SERVICE ADVISORY - NEW VALVE BRIDGE AND LASH ADJUSTER

567, 645, 710 Valve Bridge Assemblies, and Lash Adjusters

SA#: 08-020
 REVISION: A
 REVISION DATE: 8/4/08
 ISSUE DATE: 06/16/08
 AUTHOR: J. Pantos

Figure 1. NEW VALVE BRIDGE MARKING.

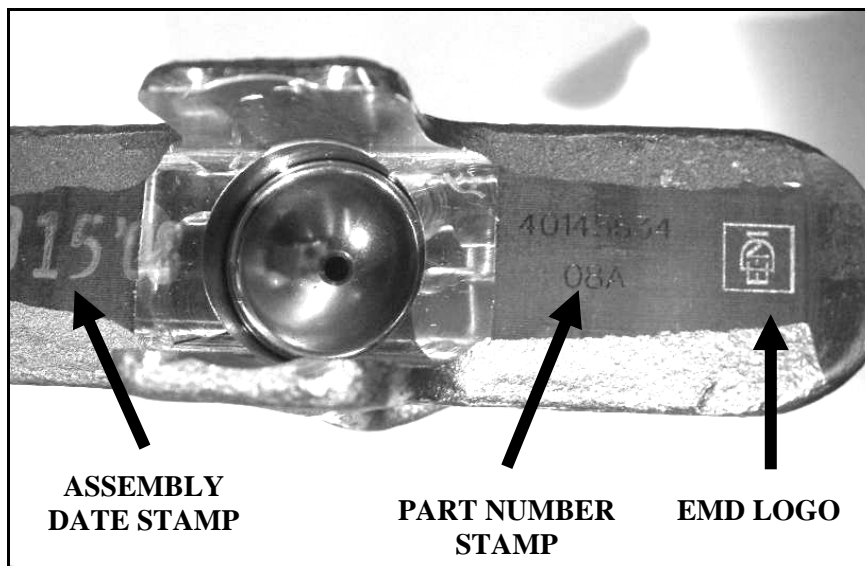
NOTE: The “part number stamp” is the part number of the machined valve bridge, not the part number of the new valve bridge assembly.

Figure 3. NEW LASH ADJUSTER - Thick Shoulder.

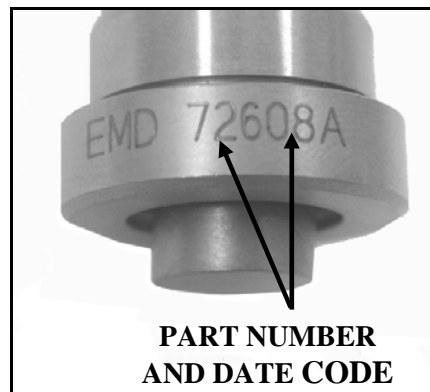
Under no circumstances should new lash adjusters be mixed with the older lash adjusters on the same valve bridge assembly. The new lash adjuster can be correctly identified by viewing Figure 3, which shows a thick collar, the last three digits of the part number, and a date code.

NOTE: The last 3 digits of the EMD part number (726) and the date code (08A) are inscribed on the thick collar of the new lash adapter.

Figure 4A. LASH ADJUSTER - Thick (P/N 40118613).

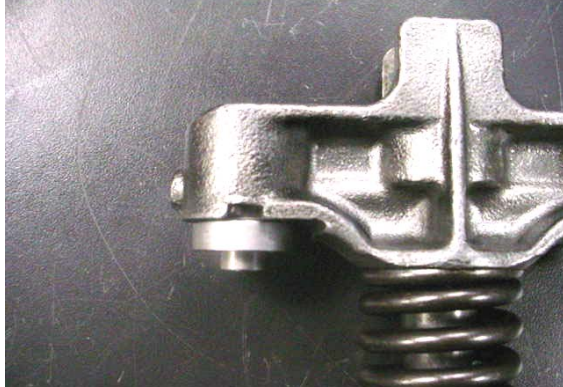
Previously issued Service Advisory 05-036 shows lash adjusters 40118613 and 8085254. Both of these part number lash adjusters are discontinued. Lash adjuster 40118613 also used a thick collar **and should not be mixed with new lash adjuster 40145726**, reference Figures 4A and 4B.

Figure 6. NEW 3/16" STYLE SEAT.

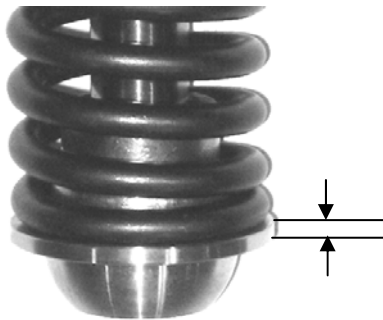
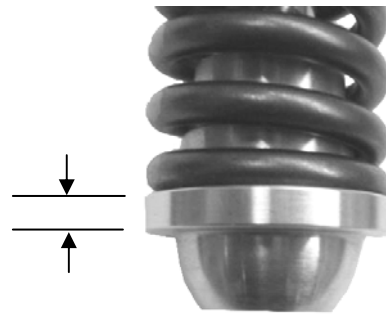
The new lash adjuster can be retrofitted into existing valve bridge bodies, providing the new valve bridge spring seats are replaced, reference comparison of Figures 5 and 6. The new part number for the valve bridge spring seat is 40140140. Valve bridge spring seats should not be changed independently of the lash adjusters.
